Z & Z Intimates Ltd

Plot # 1-3, Road # 02, CEPZ, Chittagong, Bangladesh
(22.289779, 91.777223)
07th January, 2018

Observations

Retrofitting Columns

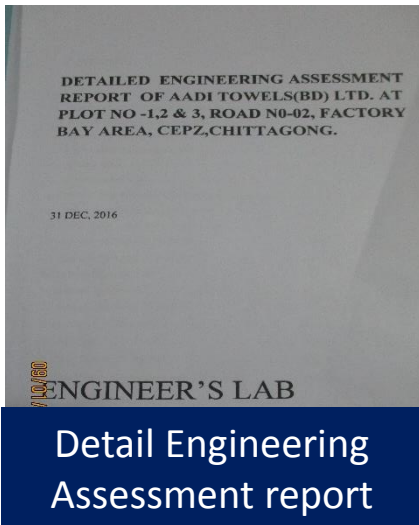
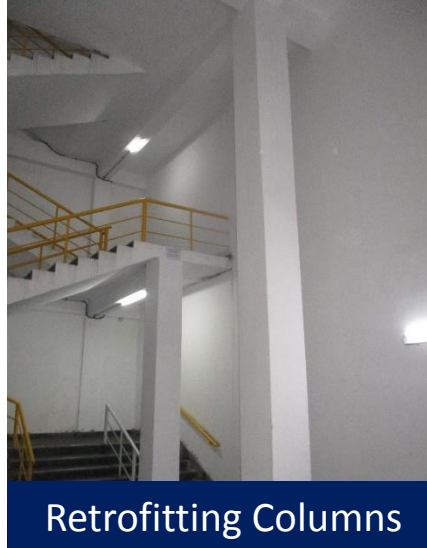
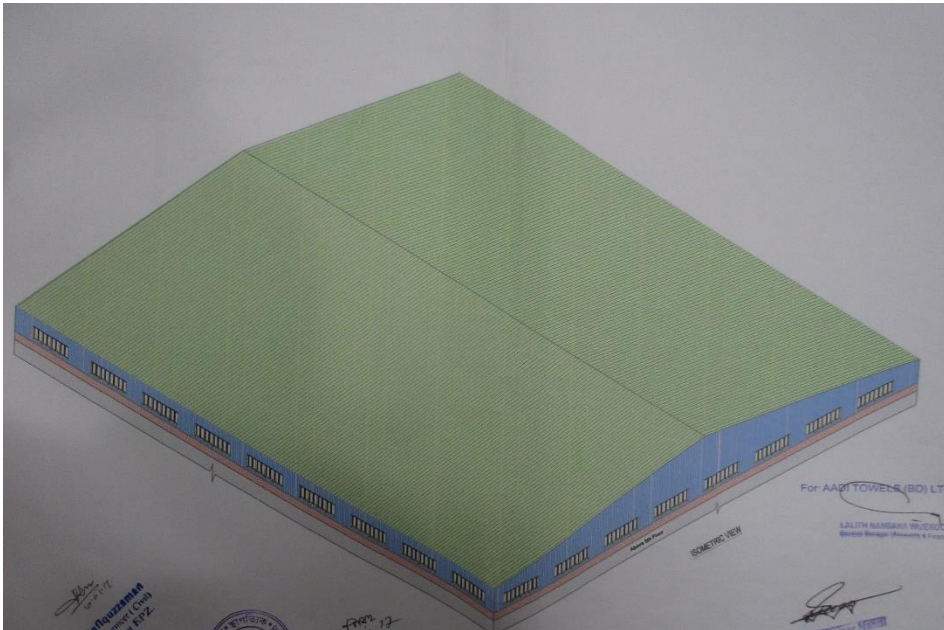
Columns were retrofitted considering concrete strength of $f'c$ =26.2 Mpa. However no test report was available. Building engineer is required to ensure the concrete strength of retrofitted column and check with code compliance.

Proposed roof top shed

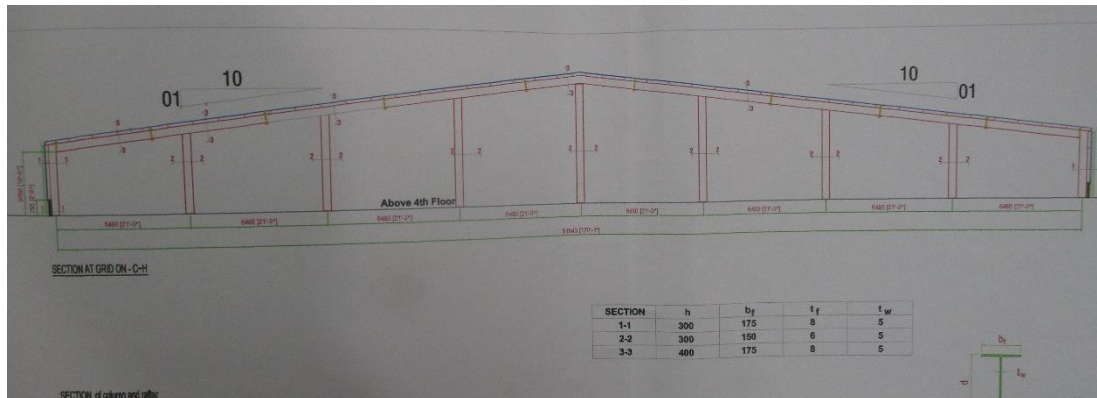
Insufficient detailing for proposed roof top shed. No obvious lateral load resisting system appeared in proposed drawing. Building engineer is required to check the lateral stability system by further reviewing Detail Engineering Assessment with ACCORD.

C-1 type column

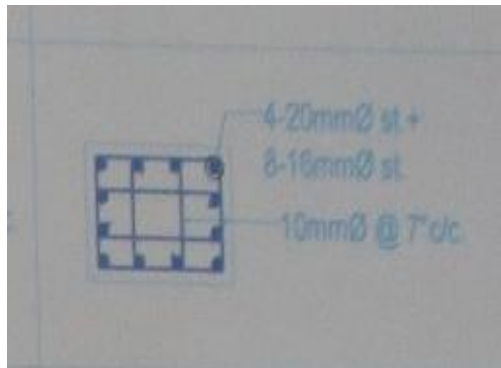
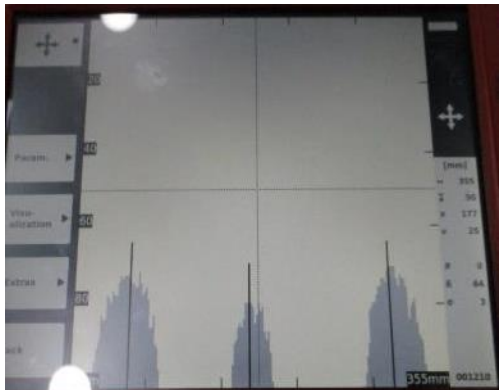
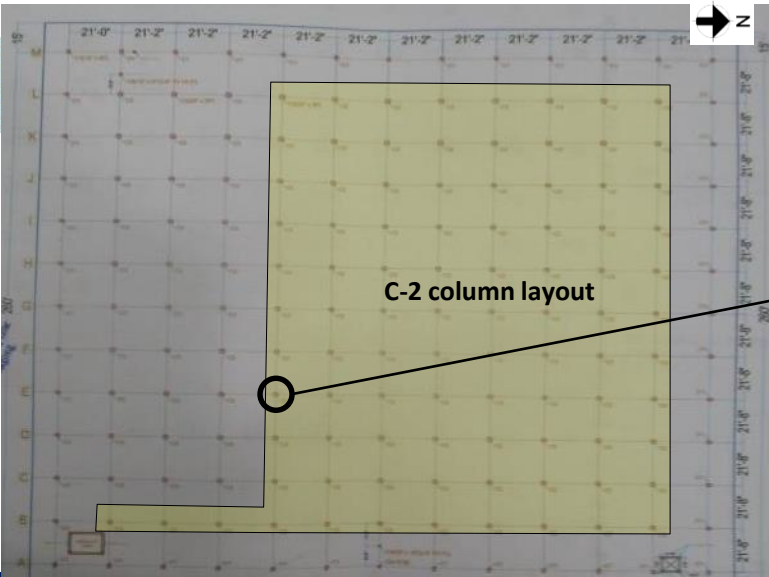
Rebar in C-1 type column was found by ferro scanning 10nos. instead of 12nos. on 4th floor.

C-2 type column

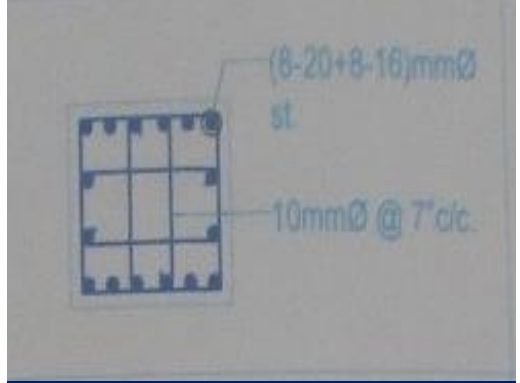
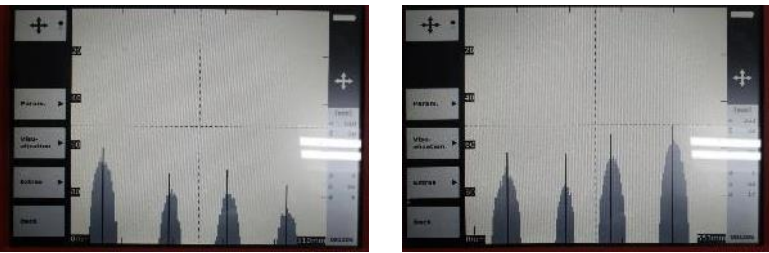
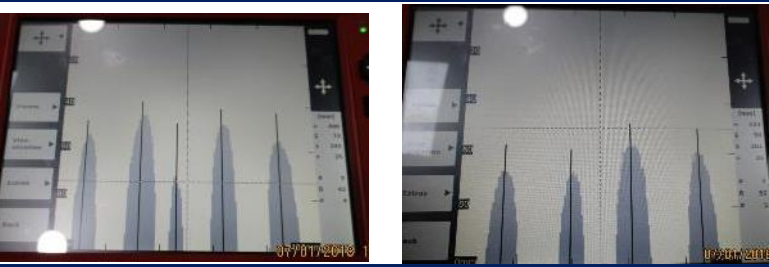
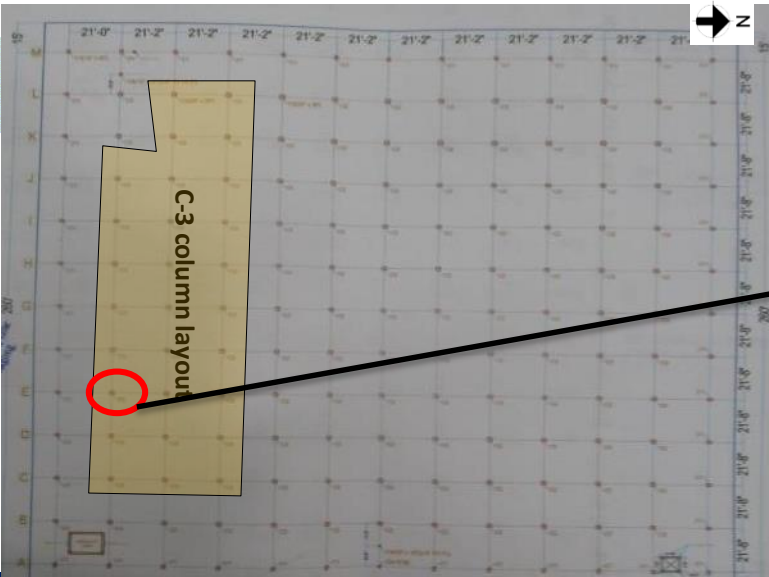
Rebar in C-2 type column was found 12nos by Ferro scanning. On 4th floor and 14 nos. On 3rd floor whereas 16 nos. rebar was shown in column schedule for 3rd and 4th floor.

C-3 type column

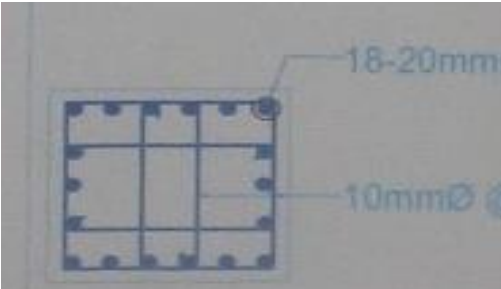
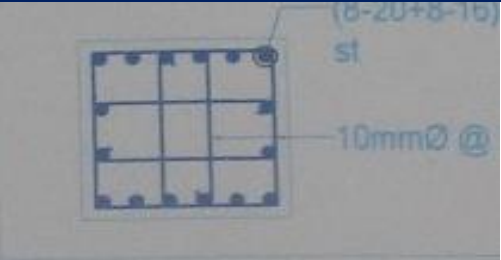
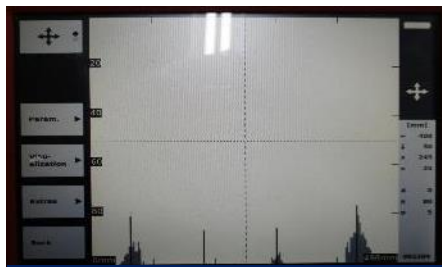
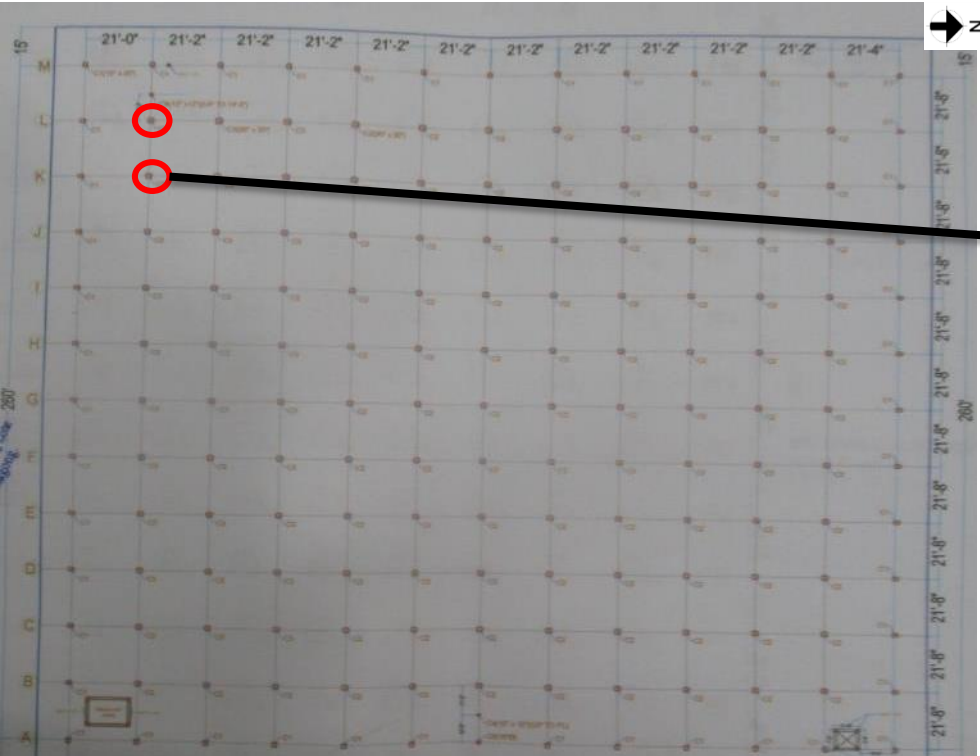
The rebar was checked by ferro scanning and found non-identical with column schedule on ground, 1st, 3rd and 4th floor.

Column Layout

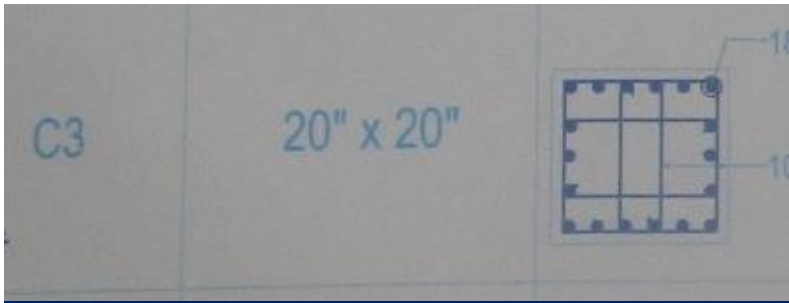
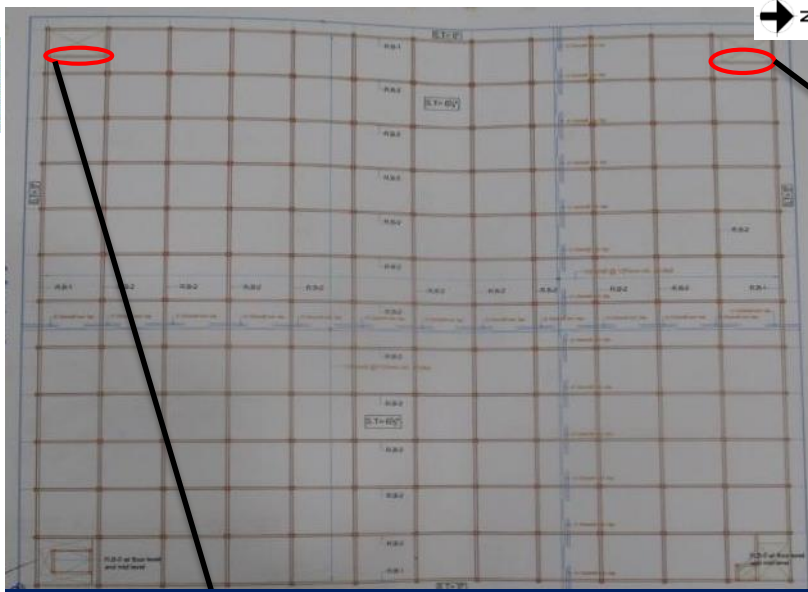
The dimension was measured 400mm x 500mm with plaster for the marked column

The dimension was measured 400mm x 500mm with render on 3rd and 4th floor but the dimension was mention 500mm x 500mm in column schedule.

Typical beam layout

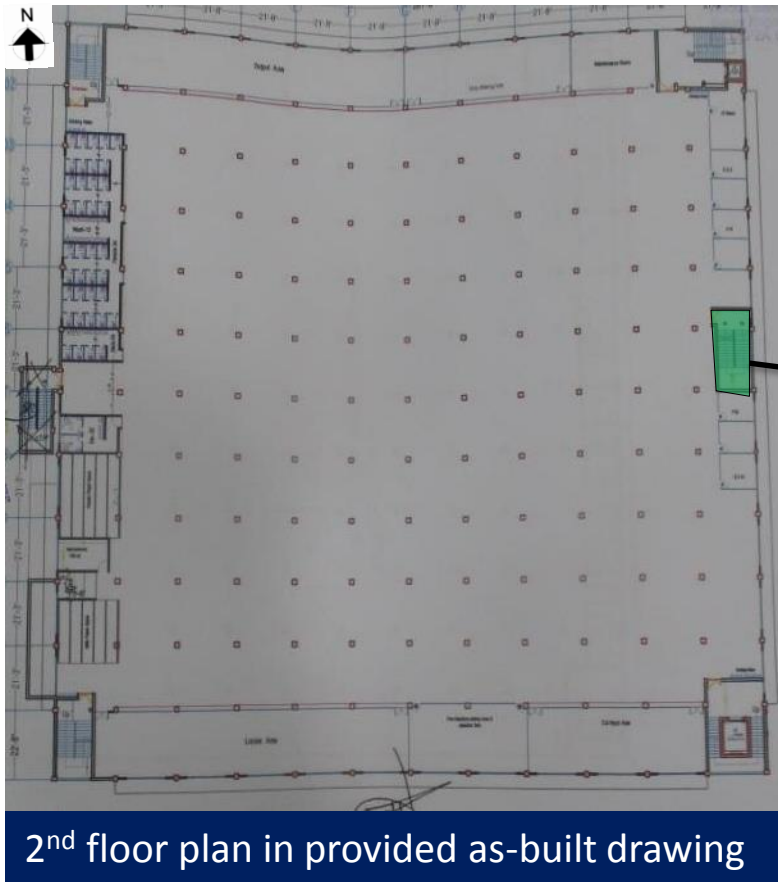
The marked beam was not found on north-west side stair case

The marked beam was not found on south-west side stair case

The marked beams on south-west and north-west side stair was not found but the beams were shown in drawing. Factory is required to revise the mentioned mismatch and produce the accurate as-build drawing.

North- East side steel stair

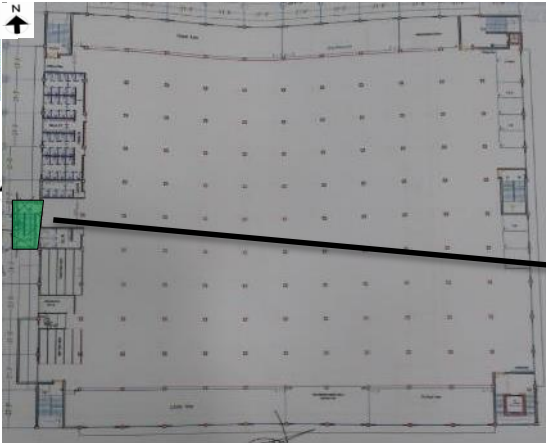
Steel column of the stair was installed adjacent with the RC column

North-East steel stair drawings was not available. Also, the steel columns of the stair are adjacent with the reinforced columns of the building.

Steel column layout in provided drawing

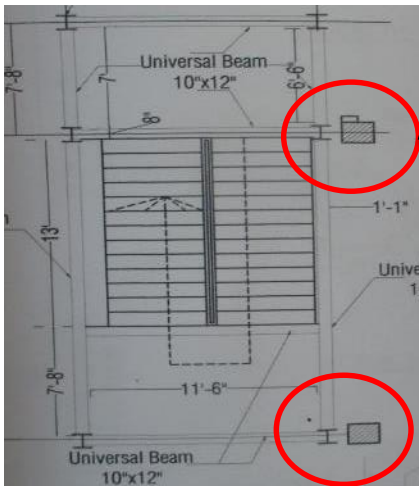
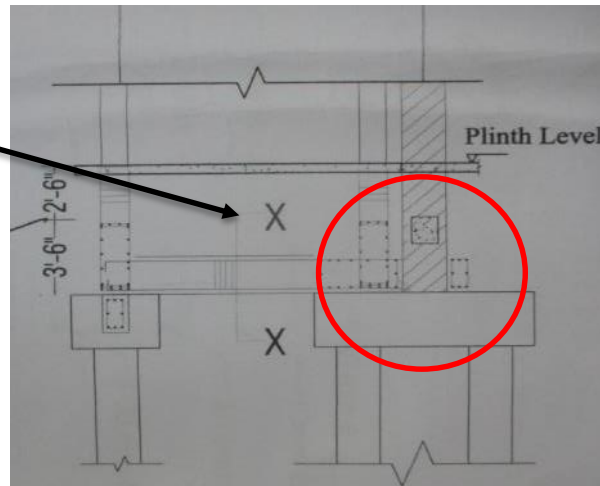
Steel columns on the east side were sheared the pile cap of the factory building's column

Connection detail of the beam – column joint and steel beam layout was not include in the provided drawing. Also, the steel columns of the stair were rest the pile cap of the reinforced column. Factory engineer is required to update the drawing and assess the foundation of the stair cases.
